CRAWFORD DRIVE SIDEWALK GAP REPORT

Crawford Drive from Rockcrest Circle to Hillcrest Park

Twinbrook Safe Routes to School and Transit Access Feasibility Studies
City of Rockville Contract No. BCS 2017-01H

December 2024

SIDEWALK GAP PLANS
CRAWFORD DR FROM ROCKCREST CIR TO
HILL CREST PARK - OPTIONS 1 AND 2

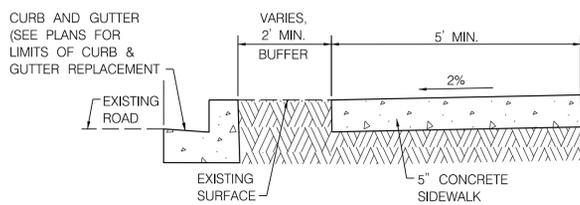
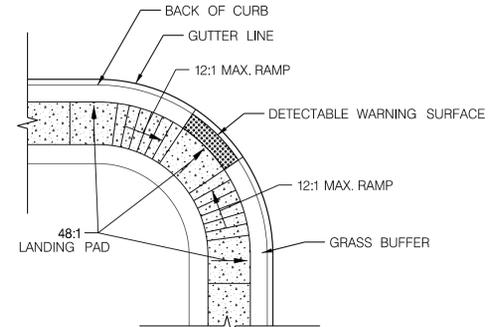
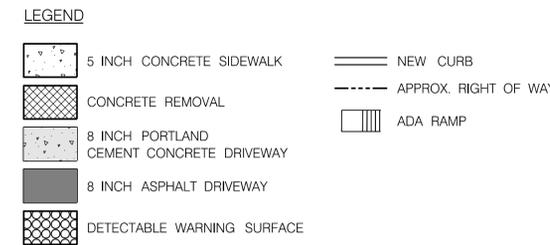
I reside at XXX Crawford Dr. and would be greatly impacted by the proposed sidewalk installation on my street. While I understand the desire for improved safety for pedestrians, the proposals, especially for the south side option in the 900 block of Crawford Dr. will ruin the landscaping in my yard and that of my neighbors. This landscaping has been present in our yards for decades. Improvements by me and my neighbors have cost thousands of dollars, none of which appears in your concept drawings to be replaced.

Additionally, the sidewalk installation would greatly reduce the front yard space that has been present since the development was created in the 1940's.

I strongly oppose Option #1 (South Side) proposal for this project.

SIDEWALK GAP PLANS
CRAWFORD DR FROM ROCKCREST CIR TO
HILL CREST PARK - OPTIONS 1 AND 2

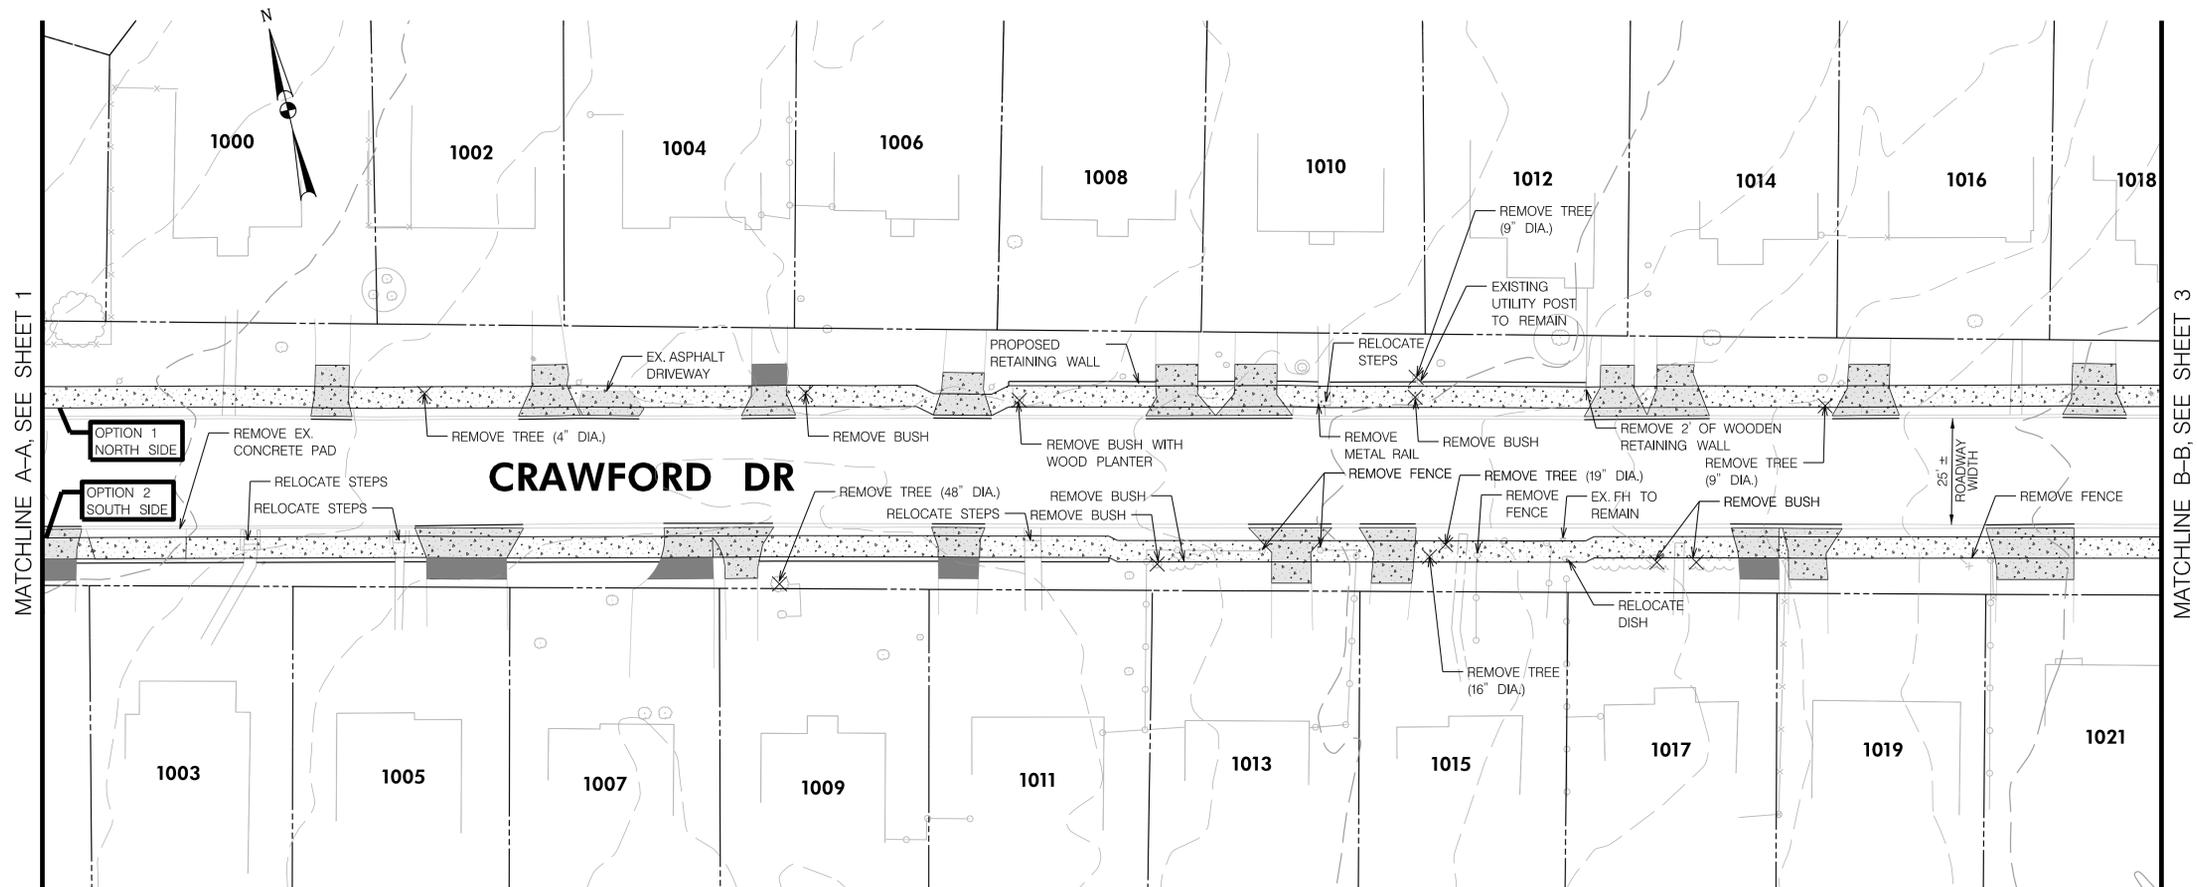
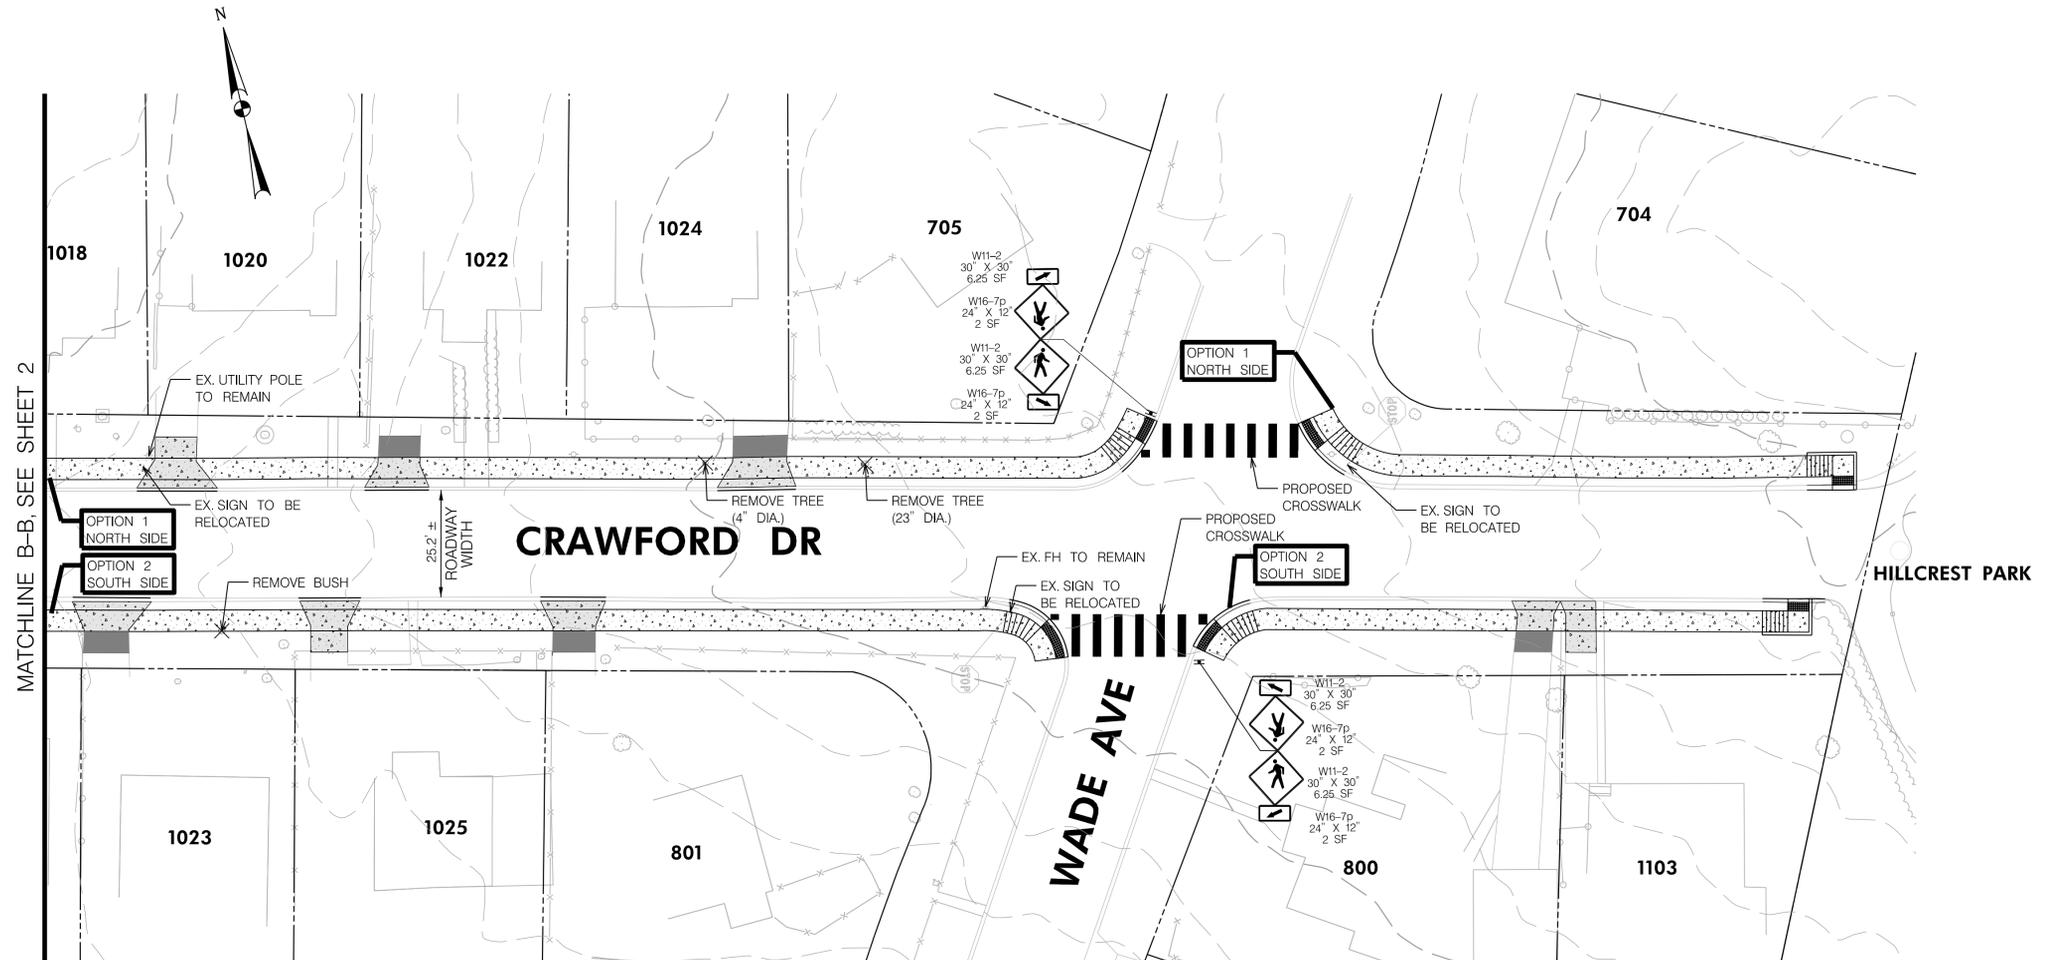
I see some missing relevant details in the map coverage of my small section of Crawford. Viewing the map with Crawford intersecting with Wade, details not indicated include:

- 1) my house, XXXX Crawford, on S. side of Crawford, is not indicated, other than property lines.
- 2) my driveway (concrete) and that of my neighbor (asphalt), running parallel to our mutual property line, are not shown. Property is even marked with "No Driveway."
- 3) Hillcrest Park, at the end of the road, next to my house, is not indicated on the map.
- 3) how the proposed sidewalks would connect with 1 of the current 2 Hillcrest Park paved paths/entrances (or a new one?) is not shown.

If such things matter here, putting the sidewalk on my side of the short Crawford extension to the park would affect my front yard and the side yard of my neighbor and 2 driveways. A sidewalk on the other side would affect the side of 1 yard, no driveways, and is flatter/less grade.

Have effects on drainage been considered? Will the new design curbs cause more problems, catch more debris, than the current curbs, which are rounded/curved, have no sharp/right angle? There are no storm sewers on the 1000 or 1100 block of Crawford, nor also uphill around the corner on Wade! With my house and neighboring Hillcrest park downhill, water collecting from far up Crawford and also Wade runs down the street sides in front of my house and dumps into Hillcrest Park, eventually entering a storm sewer downhill near the tennis court and Edmonston Drive entrance. Will any of that be changed (the parts involving Crawford Drive)? Will the new curbs help, hinder or not affect storm water flow, debris (particularly leaves in Fall, ice/snow in winter; particularly behind the wheels of parked cars) collecting and dams forming large pools in the street along the curb etc.?

Also, even without debris dams forming, the area of Crawford right at the entrance to Hillcrest park is visibly lower and water normally pools/collects there. With this at the Crawford Drive connection with the park sidewalks, seems a good time to fix this chronic problem.
